Client	MR TAYLOR AND MS SMITH
Job Title	PROPOSED ALTERATIONS TO STANLEY HOUSE LOWERGATE CLITHEROE
Drawing Title	PROPOSED SITE PLAN
Scale	1/100 AT A2
Date	NOV 2017
Drawn	POC

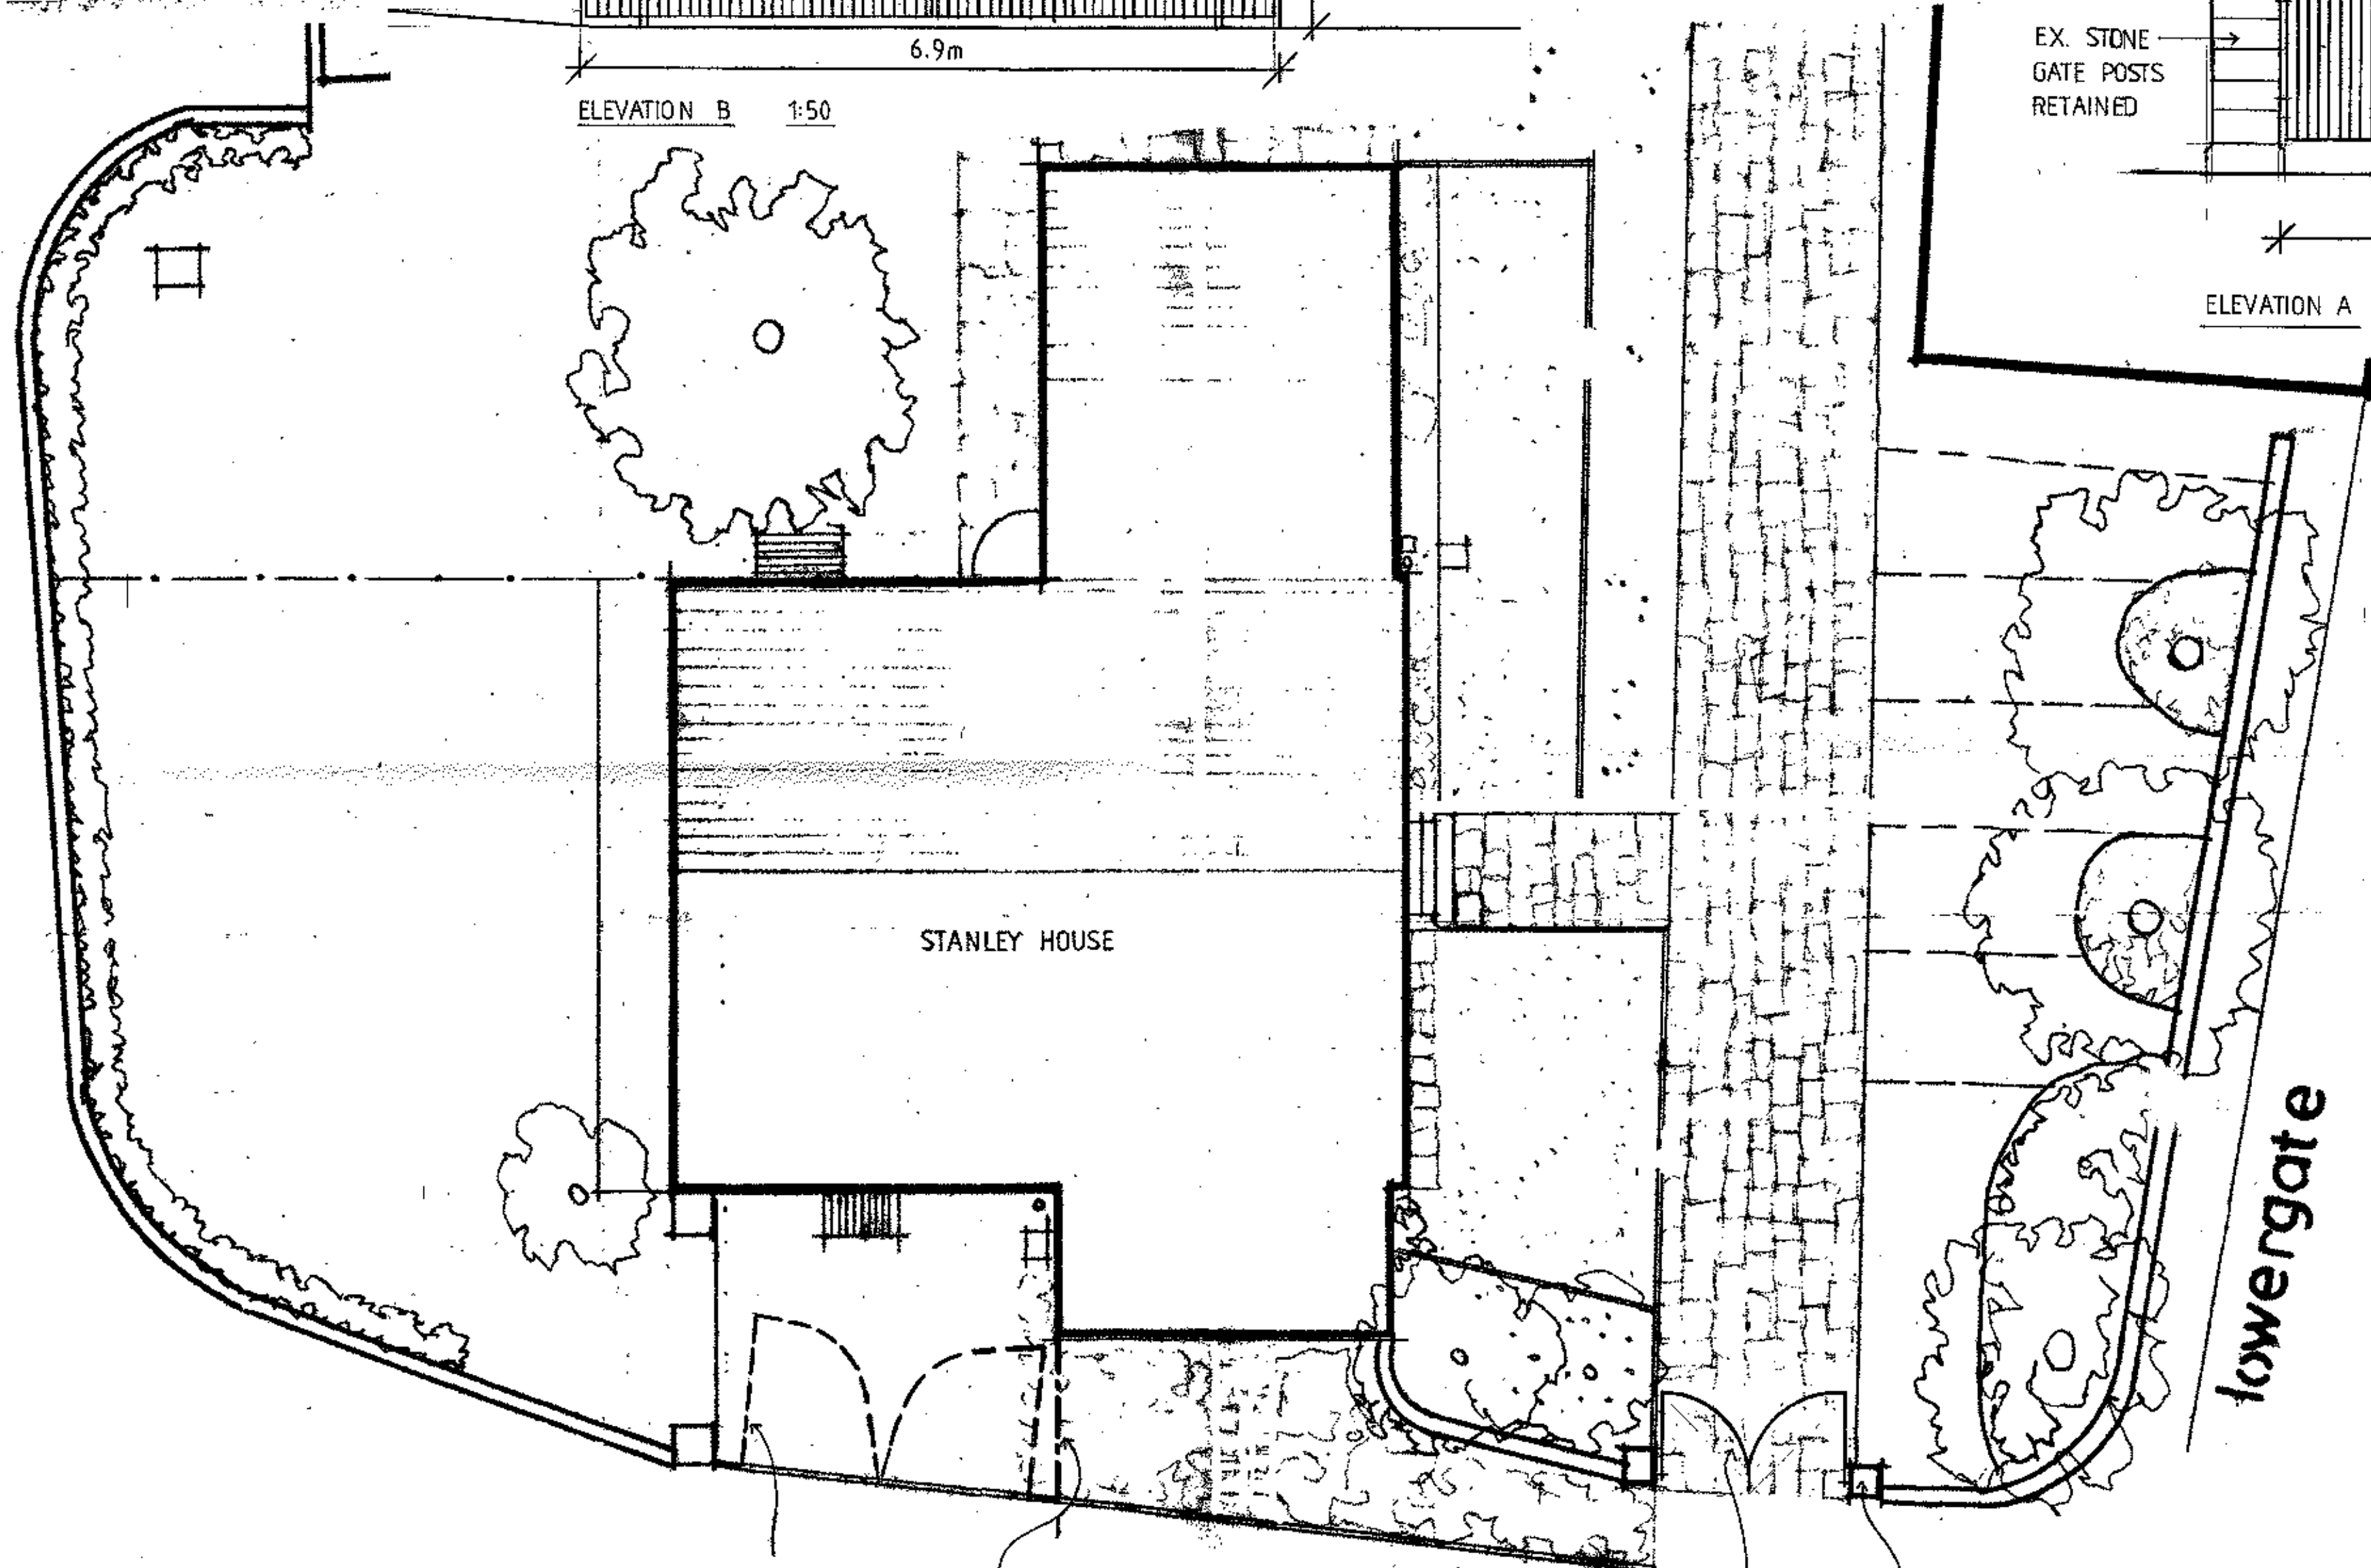
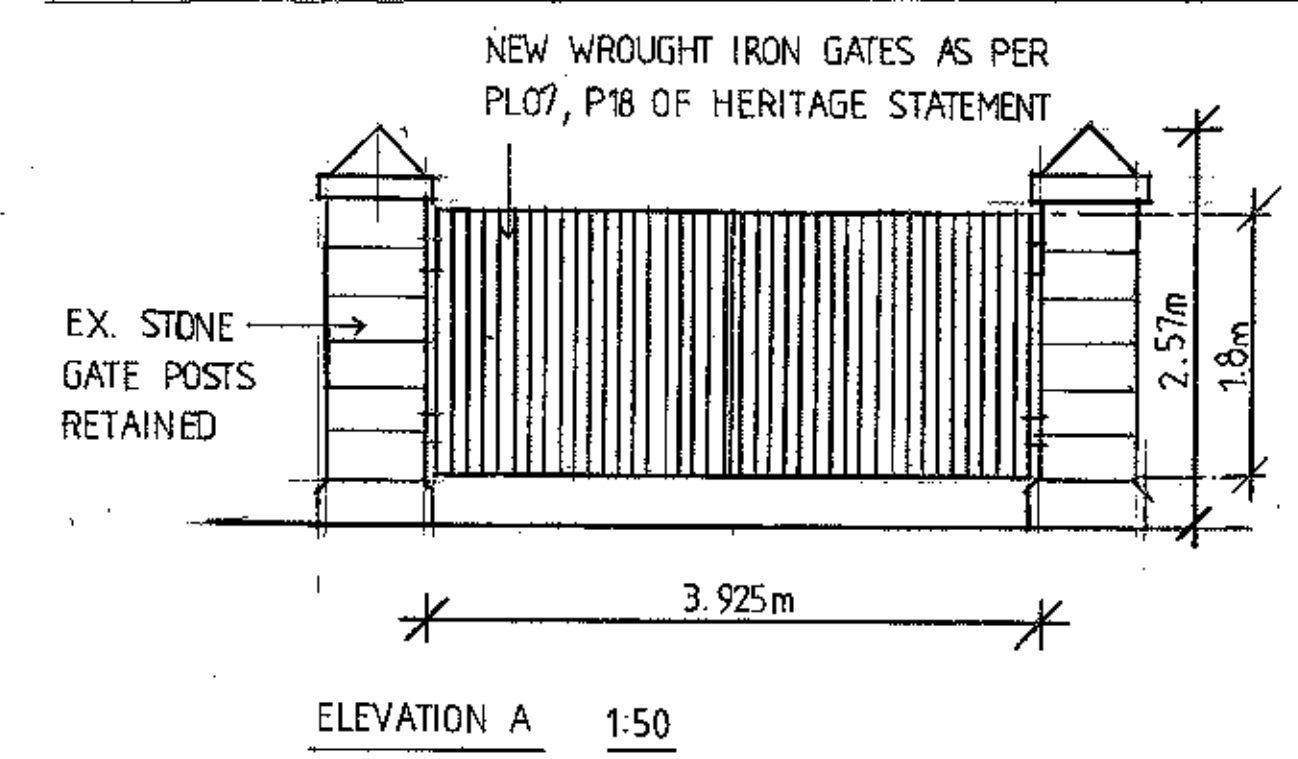
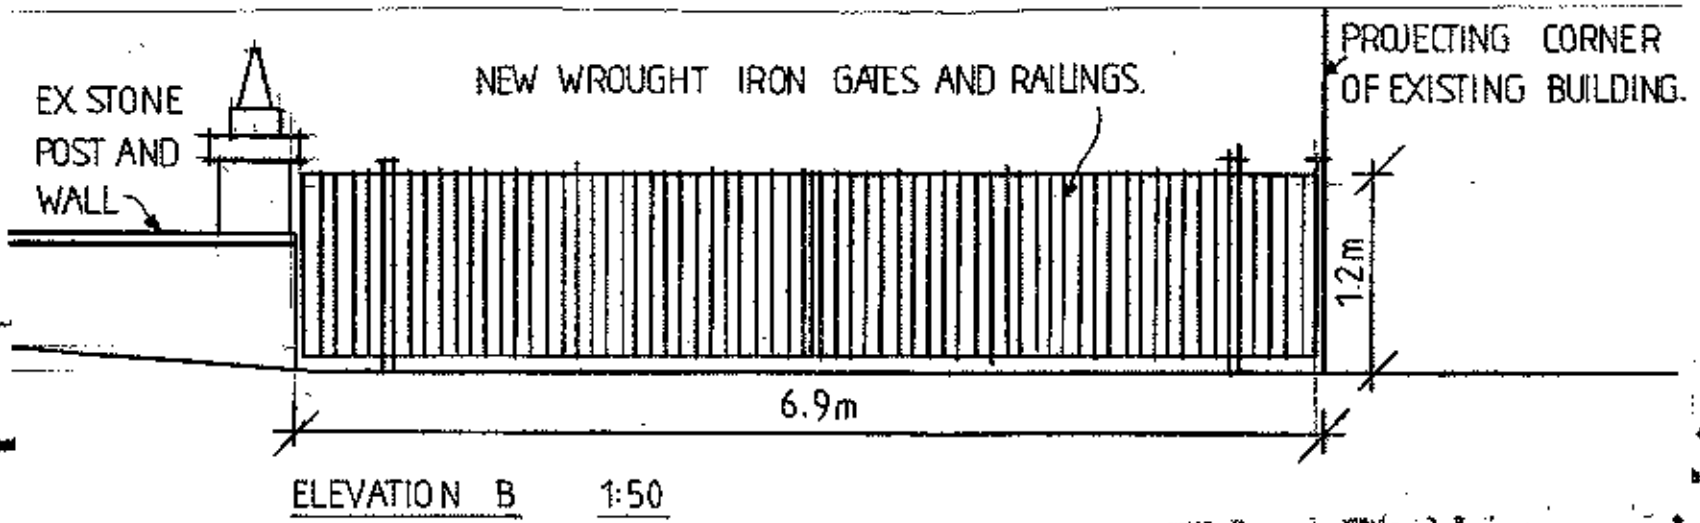
A - HEIGHT ADDED TO / FOR ENTRANCE GATES AS REQUESTED BY RVBC. 11/12/17
